CITY OF ALBUQUERQUE

Re: The Cage
4100 Central SE
Traffic Circulation Layout
Architect's Stamp dated 4-24-17 (K17D114)

DRAINAGE AND TRANSPORTATION INFORMATION SHEET (REV 11/2016)

TRAFFIC CONTROL LAYOUT

17005
AS001

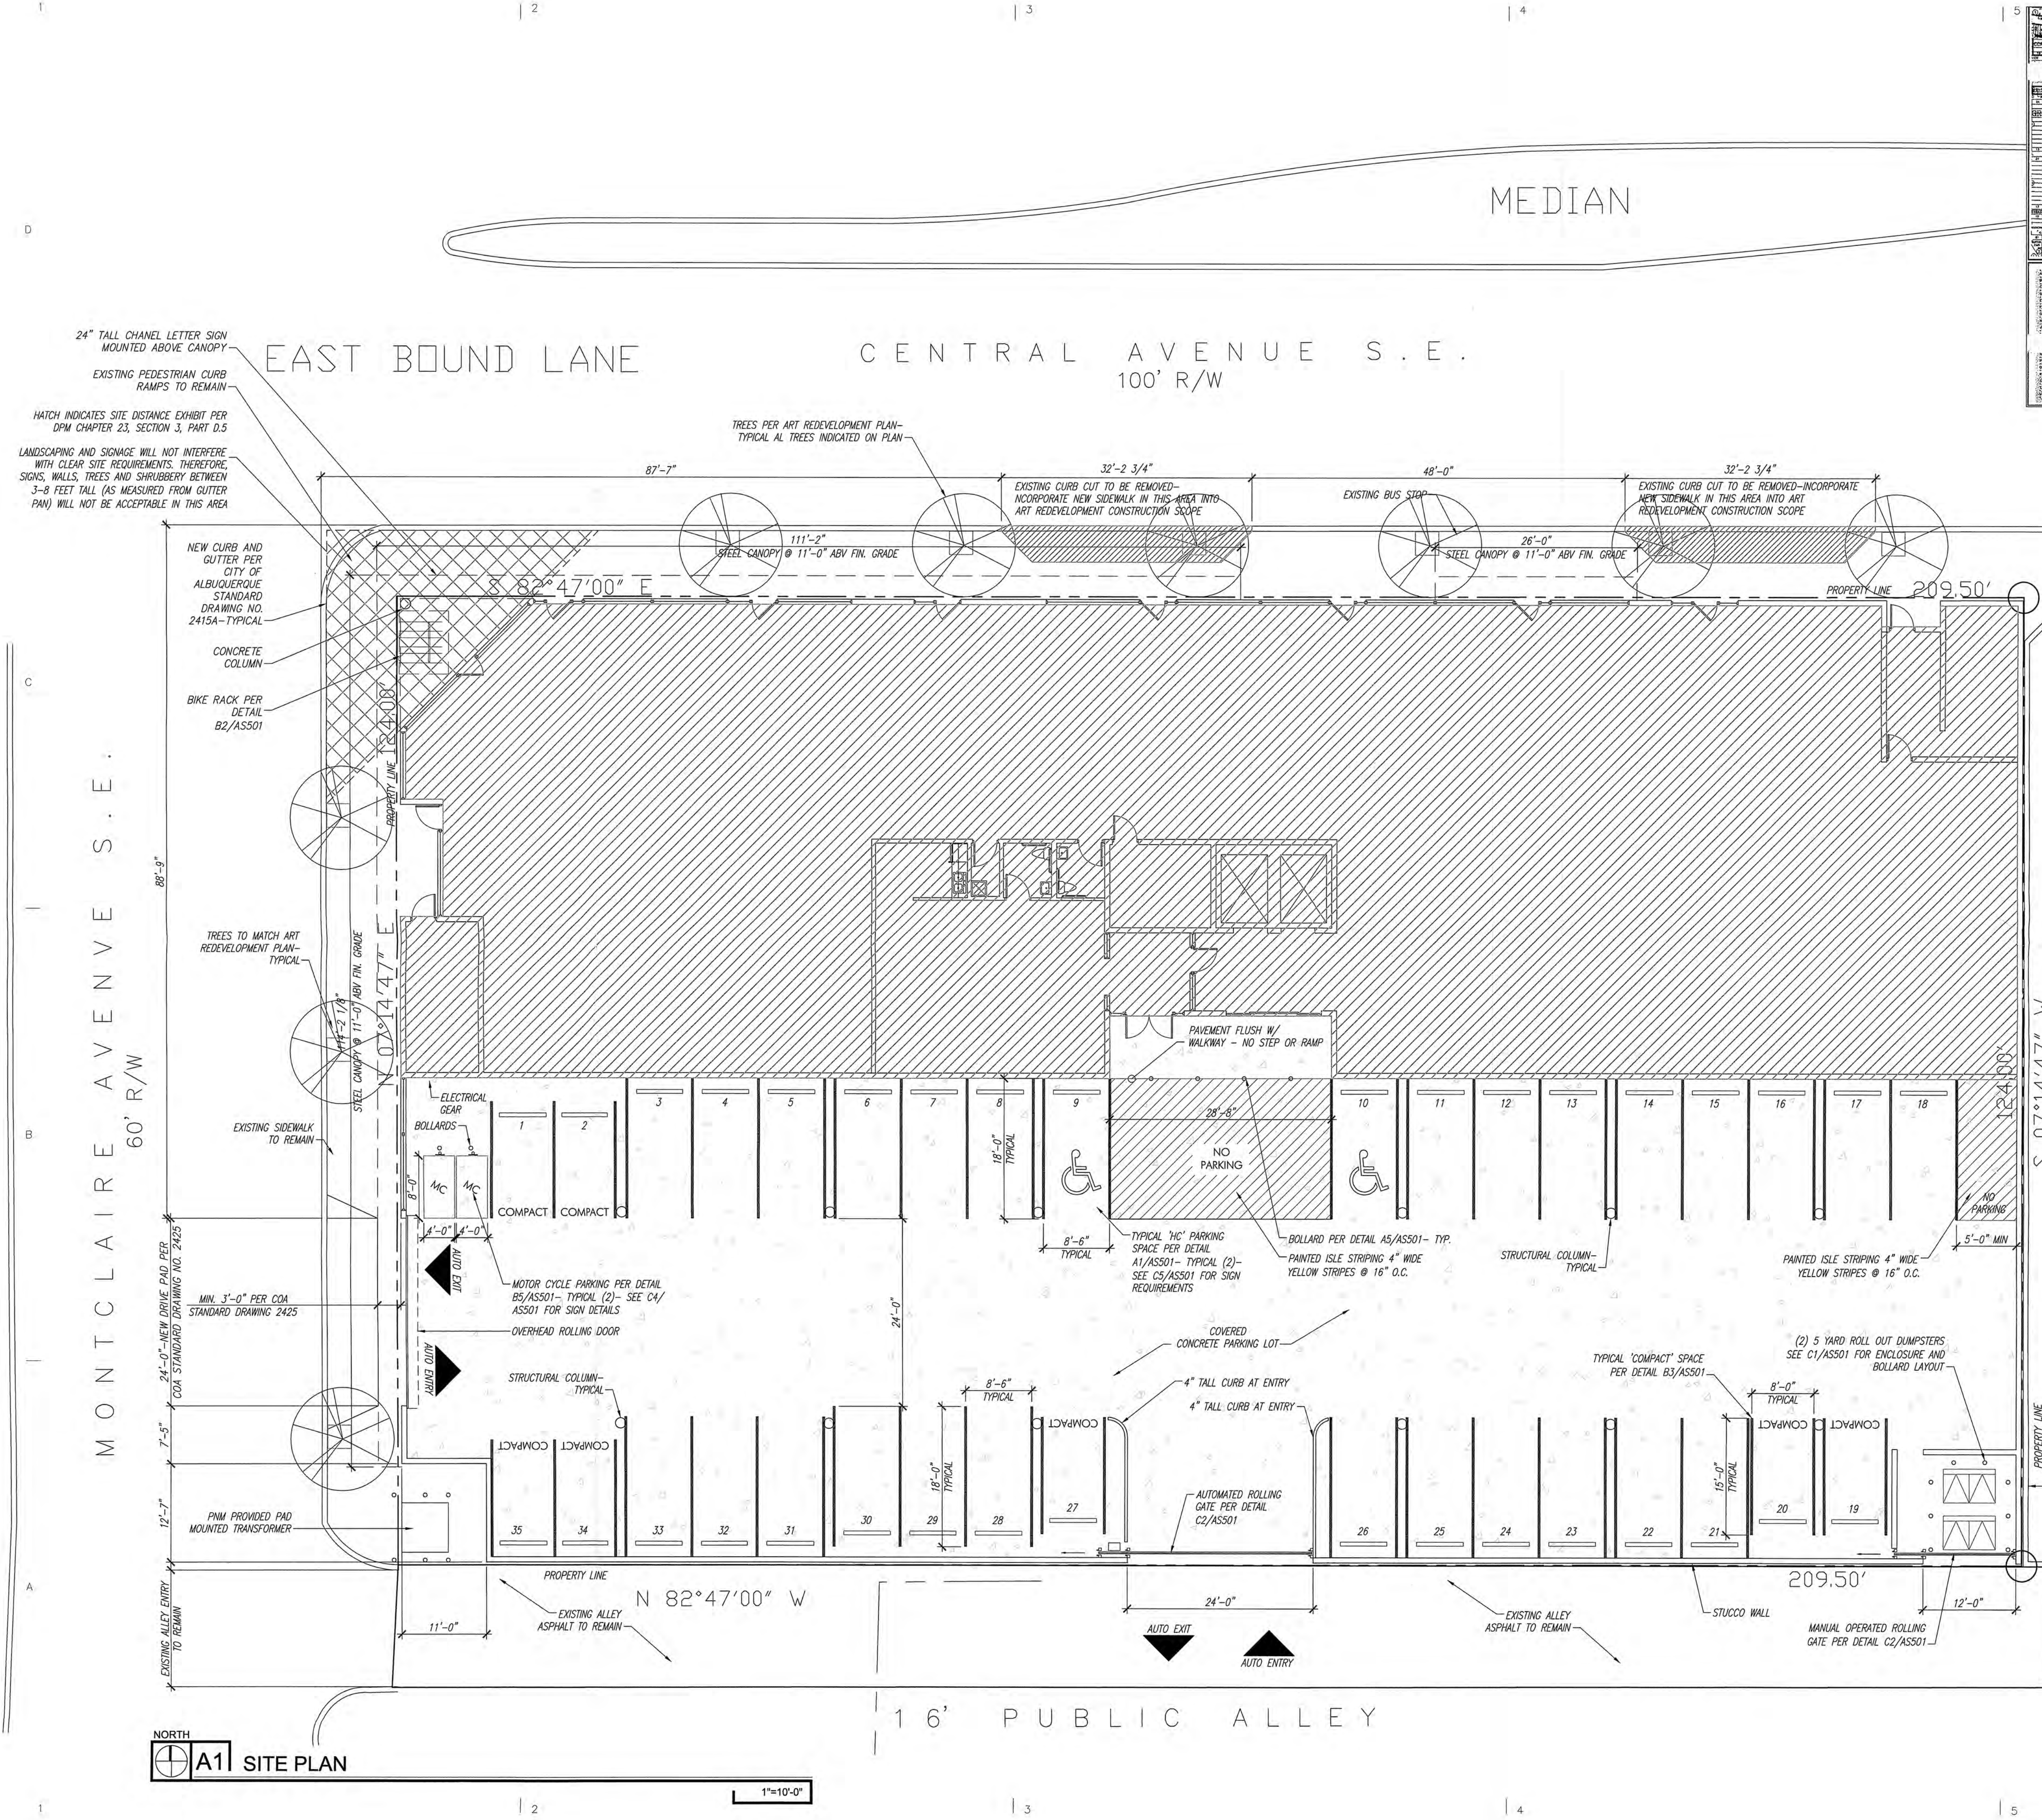
ALL WHEELCHAIR RAMPS LOCATED WITHIN THE PUBLIC RIGHT OF WAY MUST HAVE TRUNCATED DOMES.
